Proposal for amendments to ECE/TRANS/WP.29/GRPE/2012/4

“**Figure 20**
Schematic of Recommended Particle Sampling System – Full Flow Sampling”

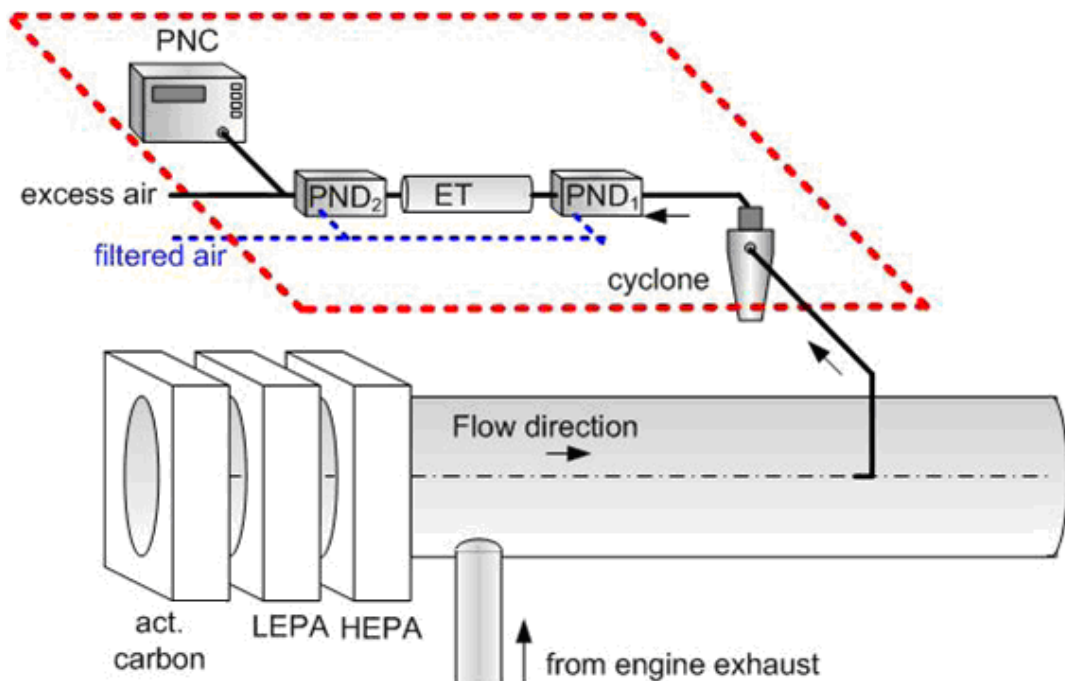
Annex 4, Appendix 8 Figure 20, replace with:

WLTP DTP PM-PN subgroup discussions also identified an error in the particle number measurement diagram in Regulation 49, in that the sequence of dilution air filters was incorrect and at odds with the text of the Regulation.
